ATTACHMENT B

MARKED-UP TECHNICAL SPECIFICATIONS

INDEX

FIGURE 3.4-2

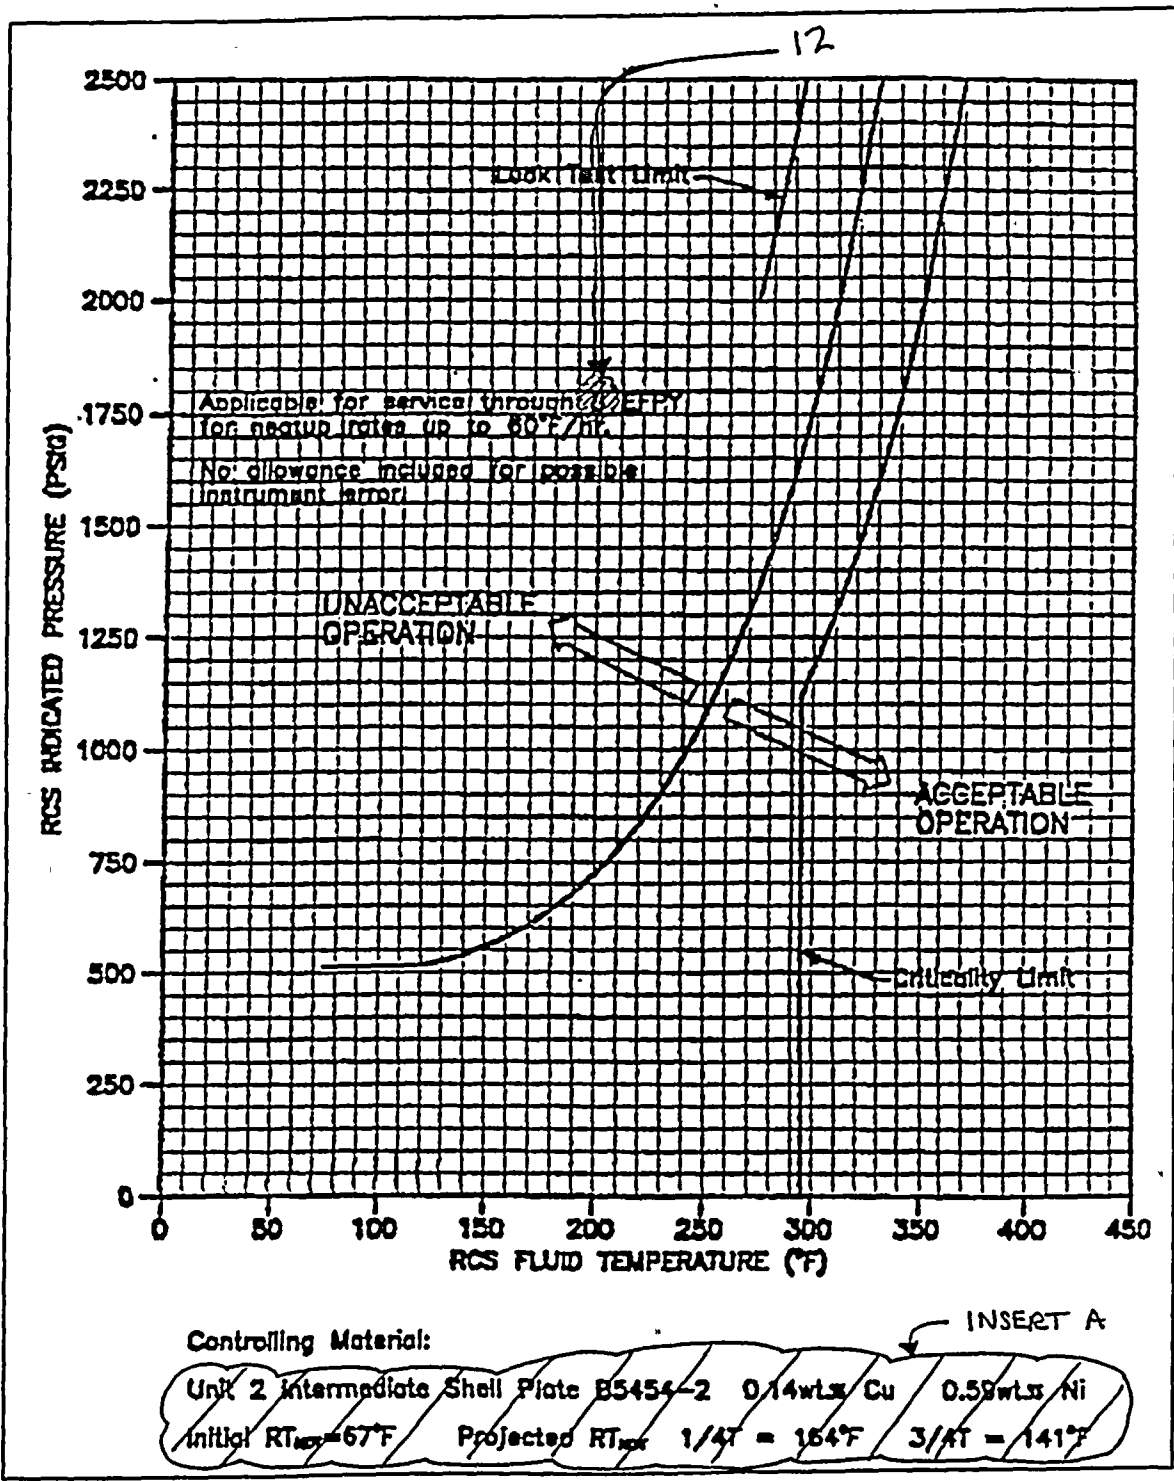
REACTOR COOLANT SYSTEM HEATUP LIMITATIONS - APPLICABLE UP TO 83 EFY

Page 3/4 4-31
Insert A

1/4T: Unit 1 Lower Shell Longitudinal Weld 3-442 C. $RT_{ndt} @ 1/4T = 161^{\circ}F.$
3/4T: Unit 2 Intermediate Shell Plate B5454-2. $RT_{ndt} @ 3/4T = 131^{\circ}F.$

FIGURE 3.4-3

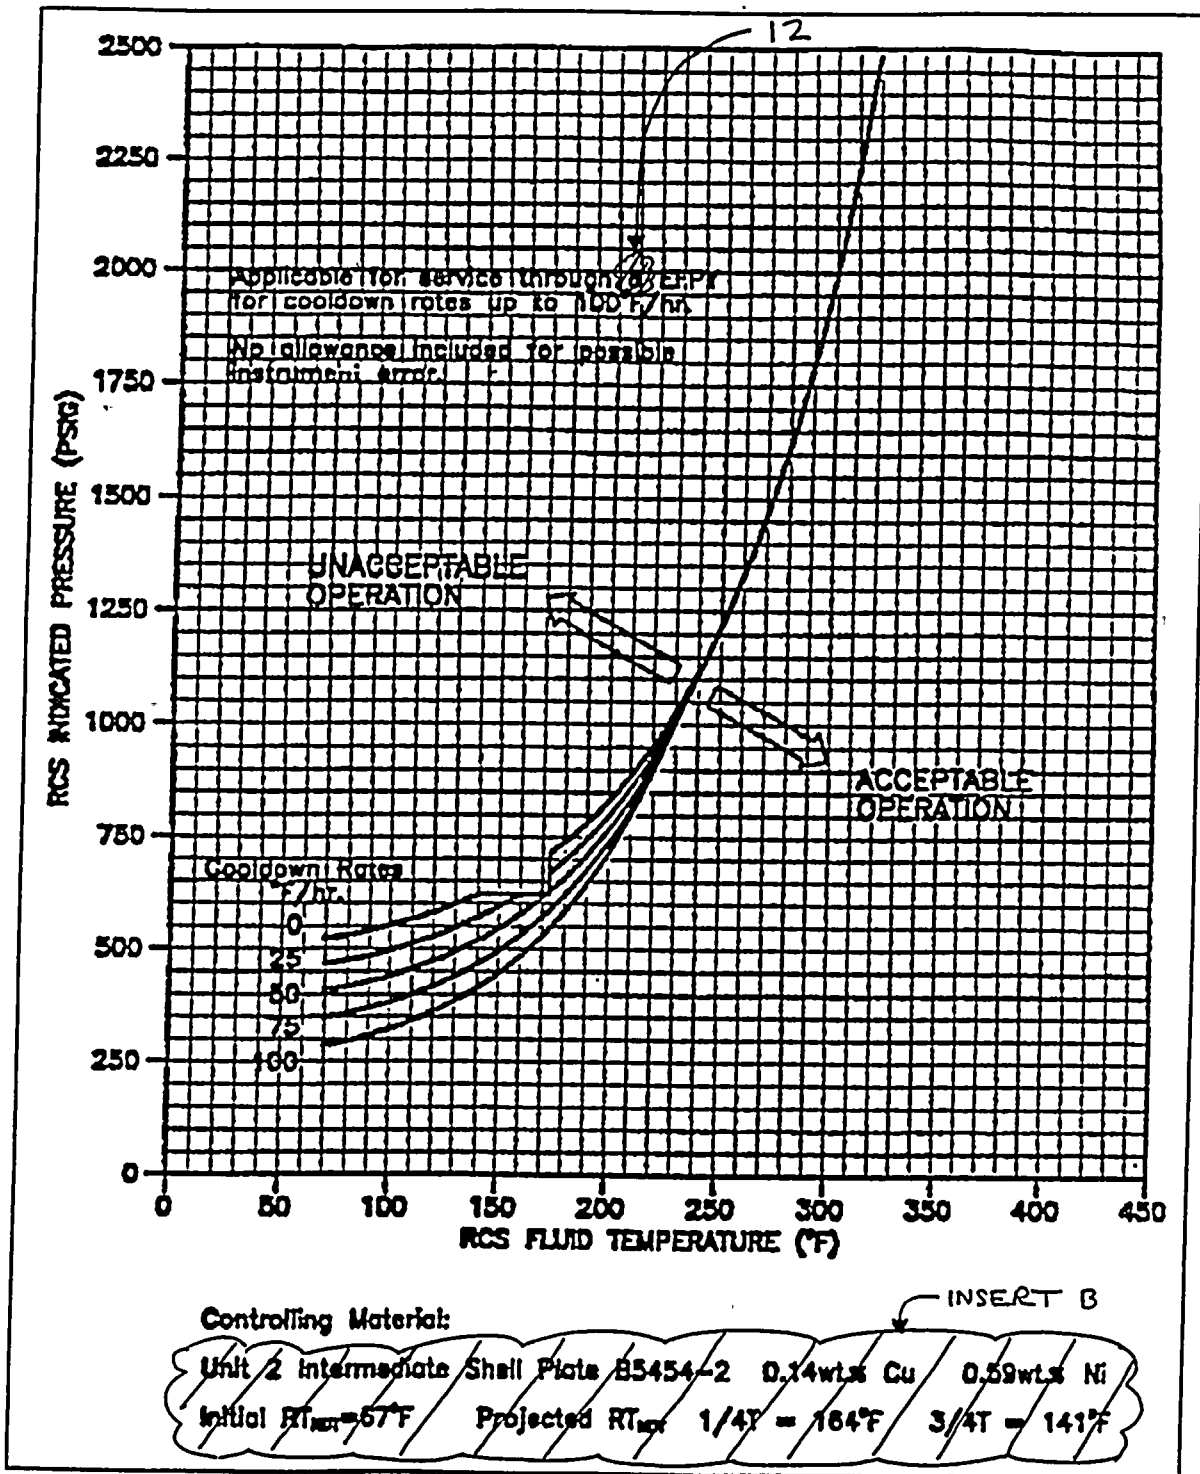
REACTOR COOLANT SYSTEM COOLDOWN LIMITATIONS - APPLICABLE UP TO 87 EPF

Page 3/4 4-32
Insert B

1/4T: Unit 1 Lower Shell Longitudinal Weld 3-442 C. RT_{ndt} @ 1/4T = 161°F.
3/4T: Unit 2 Intermediate Shell Plate B5454-2. RT_{ndt} @ 3/4T = 131°F.
